Heavy Use Area Protection Project Design CIG Project – HUAP surface using wood chips

Dewy Meadows Farm

Warren Township, Bradford County

As-Built in Red ✓
AS BUILT PLANS
dated 12/28/18

HUAP PAD LAYOUT
 DEWY MEADOWS FARM
 HEAVY USE AREA PROTECTION
 BRADFORD COUNTY, PENNSYLVANIA

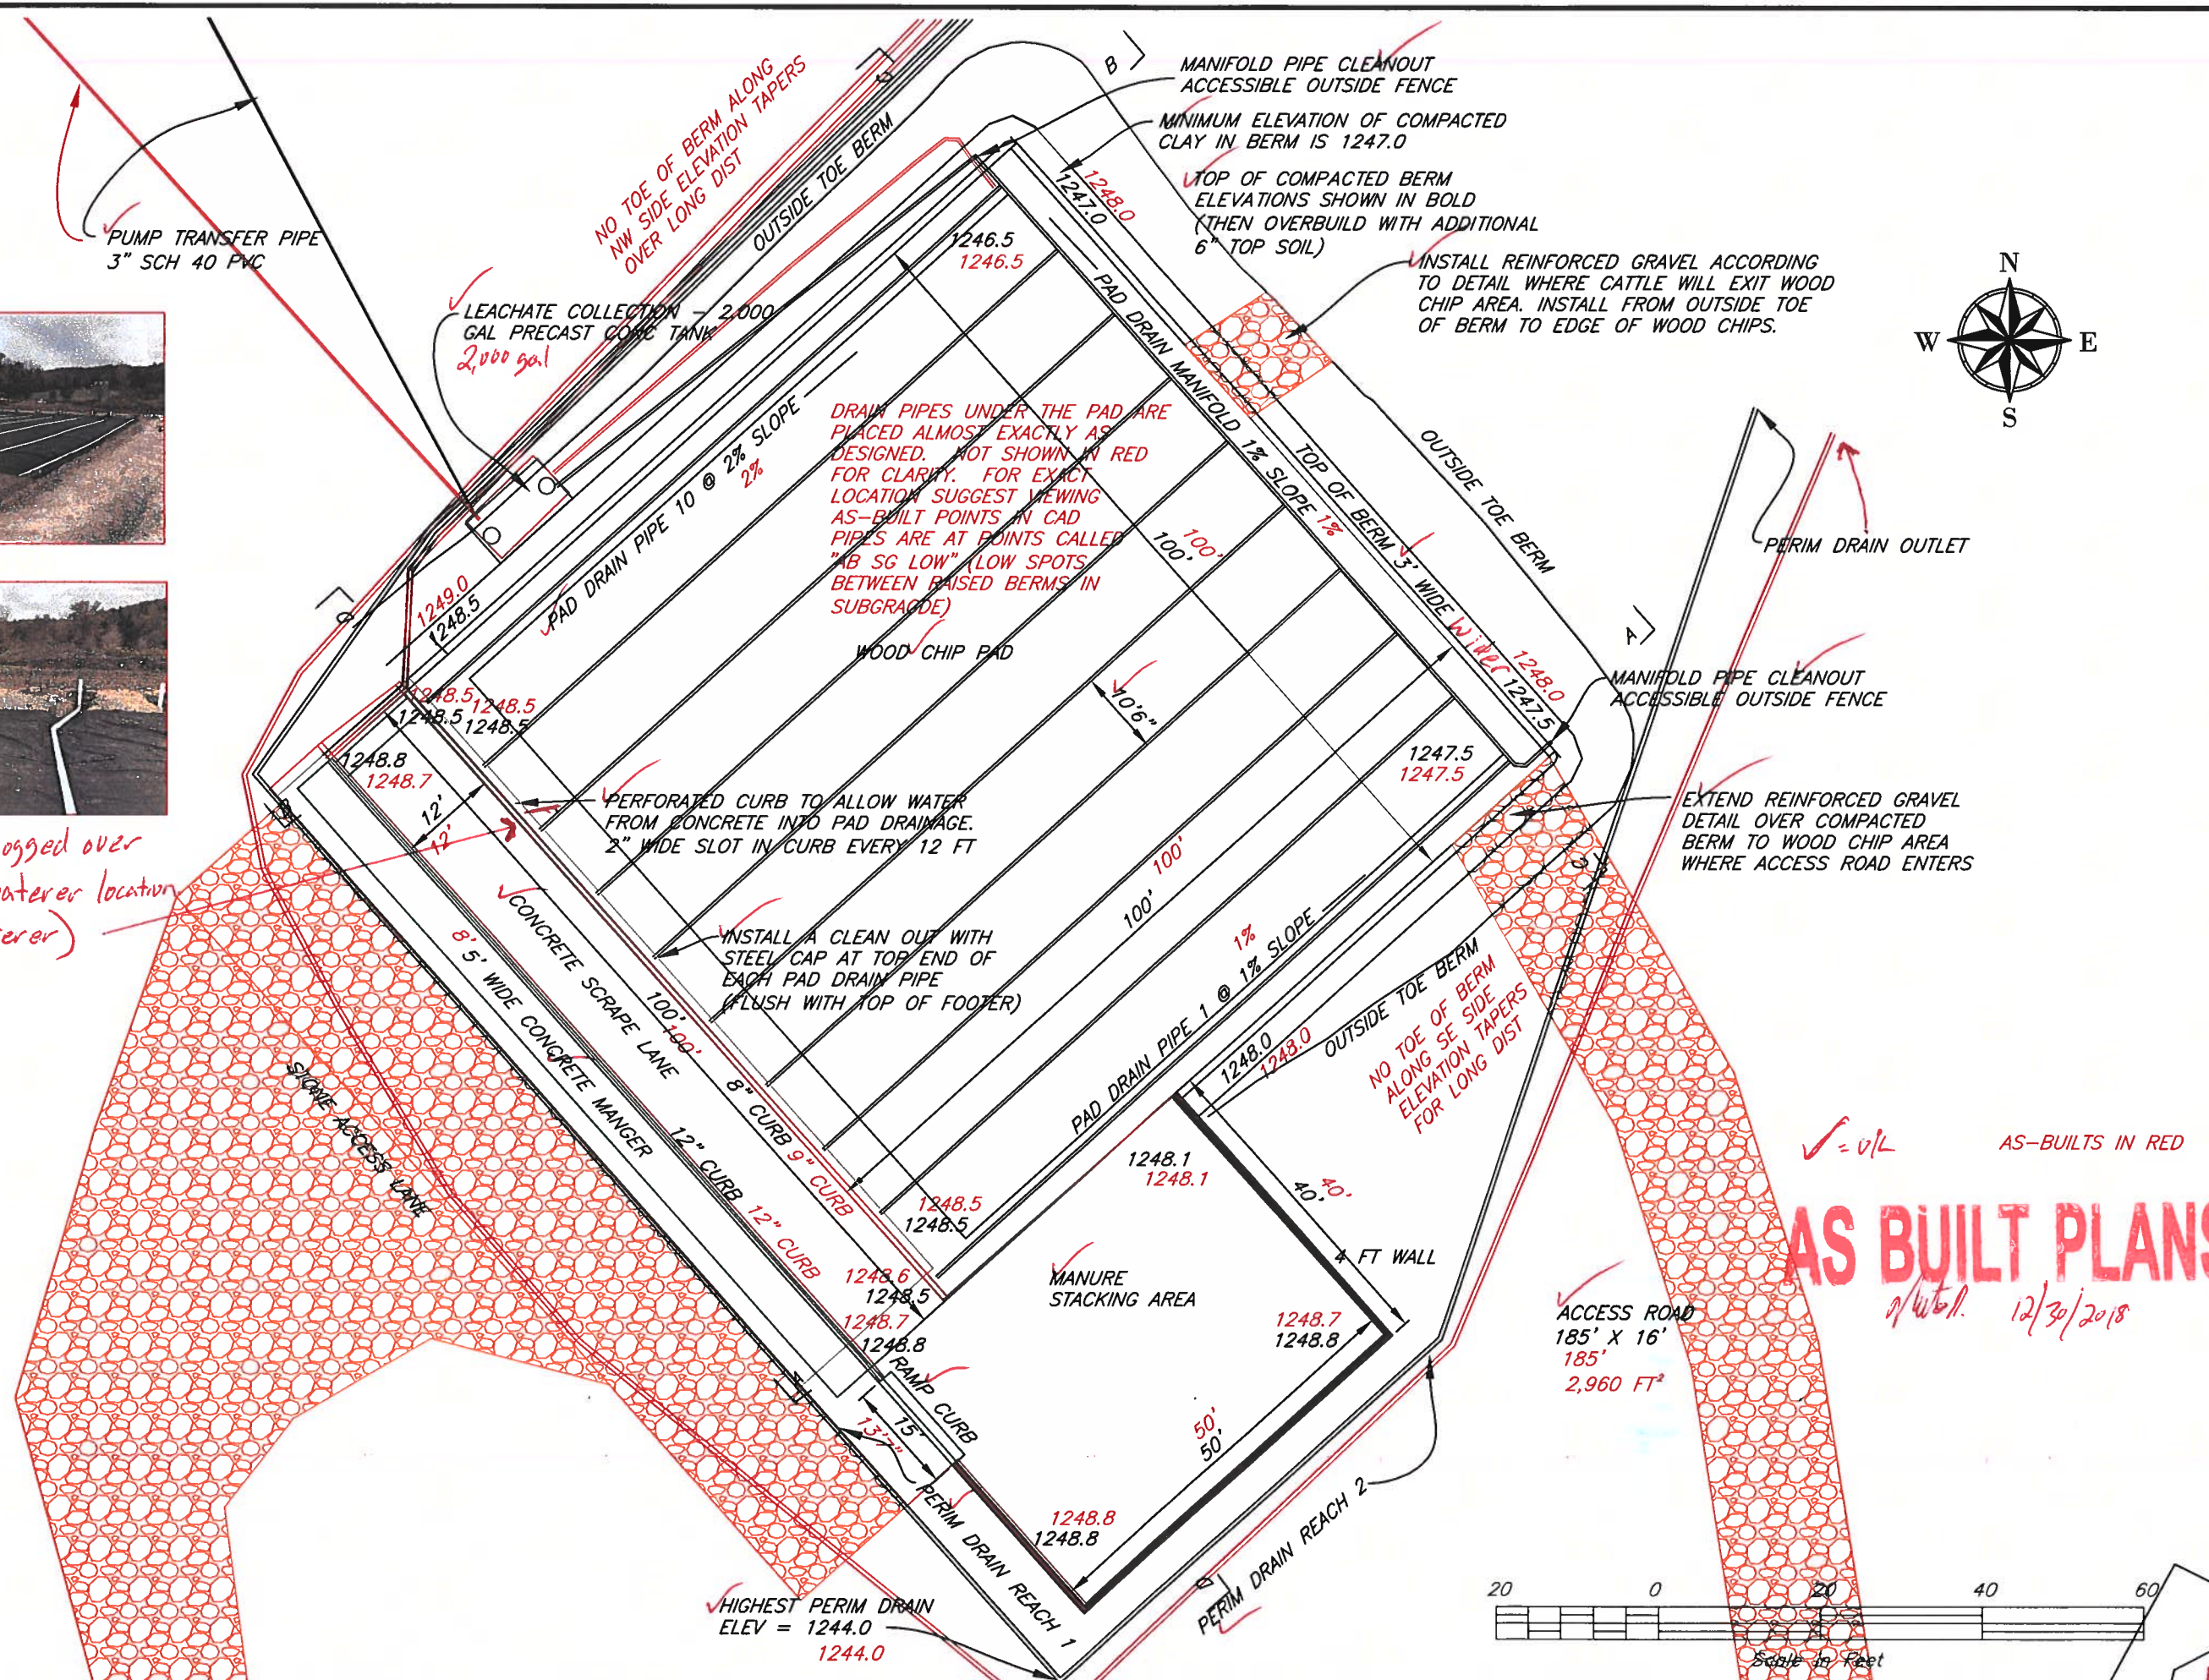
One pipe jogged over to avoid waterer location (a NW waterer)

PERIM DRAIN REACH 1 PROFILE

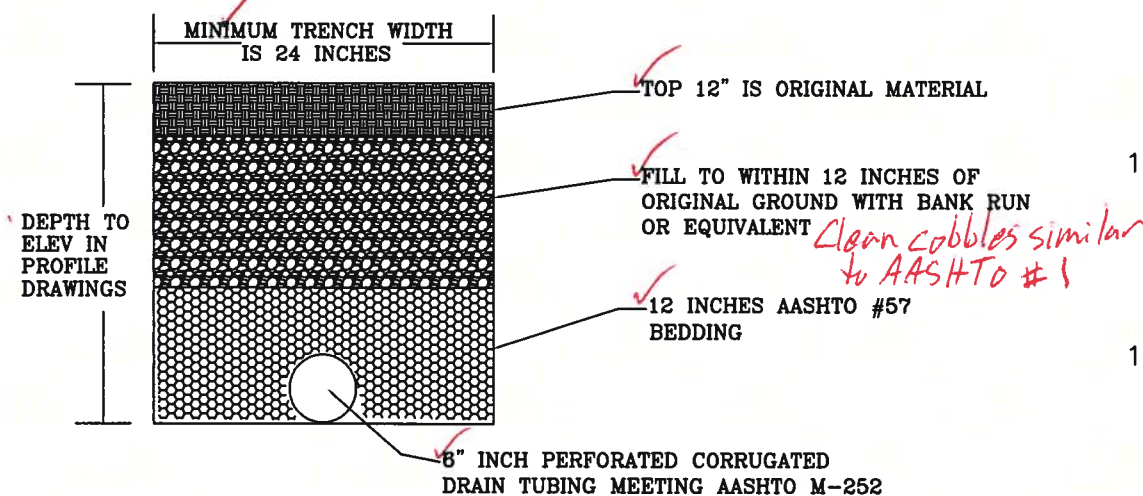
AS-BUILT QUANTITIES
SUBSURFACE DRAIN = 442'
UNDERGROUND OUTLET = 90'

PAD DRAIN MANIFOLD PROFILE

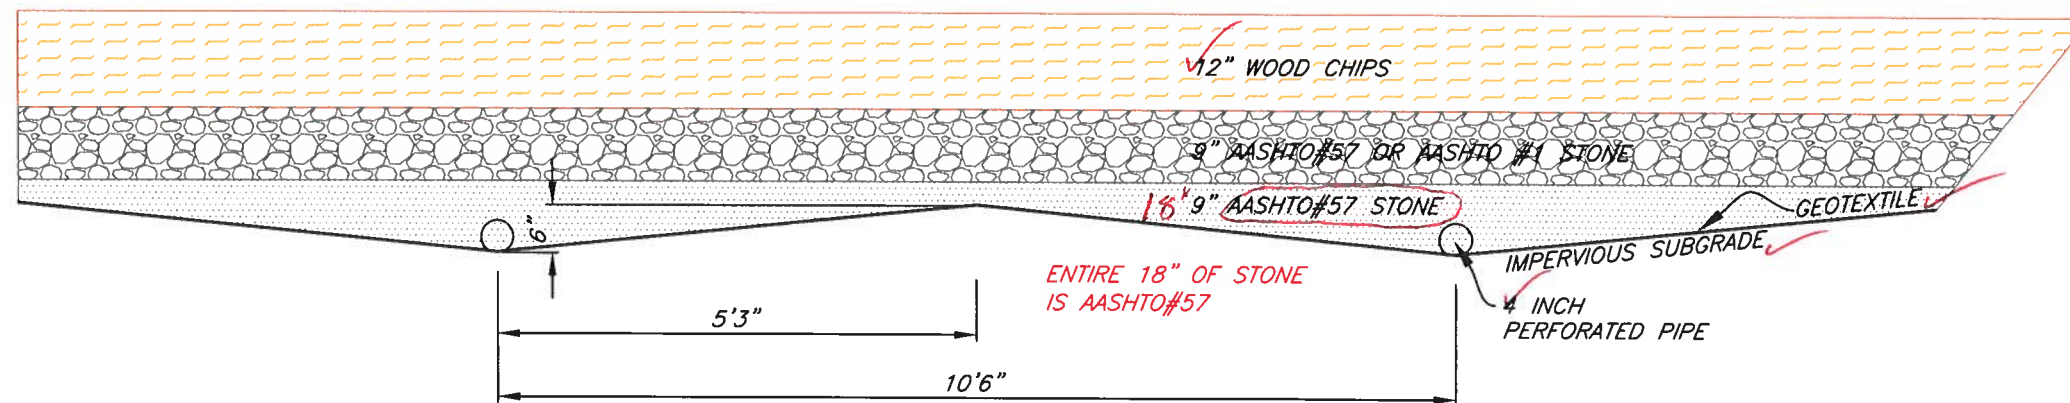
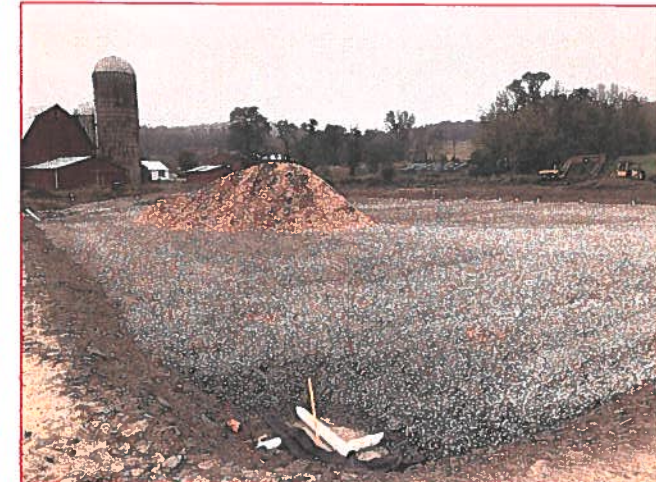
- NOTES**
- ✓ - 4 INCH PERFORATED DRAIN PIPE IS ADS 3000 TRIPLE WALL WITH THREE ROWS PERFORATIONS @ 60 DEGREES - HOLES PLACED DOWN
 - ✓ - DRAIN PIPE IS SPACED 10'-6" ON CENTER. 1.0% MINIMUM GRADE ON ALL DRAINAGE PIPE
 - ✓ - IMPERVIOUS SUBGRADE SLOPES AT 6" DROP TOWARD DRAIN PIPE IN EACH DIRECTION
 - ✓ - DRAIN PIPE BEDDED WITH AASHTO#57 STONE (MINIMUM 9") 18"
 - ✓ - TOTAL DRAINAGE STONE DEPTH = 18" ✓ TOP 9" OF STONE CAN BE AASHTO #57 OR AASHTO #1 ENTIRE 18" OF STONE IS AASHTO#57
 - ✓ - GEOTEXTILE PLACED ON TOP OF IMPERVIOUS SUBGRADE, BELOW DRAINAGE
 - ✓ - GEOTEXTILE SHALL BE ADS 701 (NON-WOVEN) OR EQUIVALENT
 - ✓ - WOOD CHIPS ARE HARDWOOD AND SCREENED TO REMOVE FINES; APPROX SIZE OF CHIP 2" X 2" X 0.25"; PLACED 12 INCHES THICK
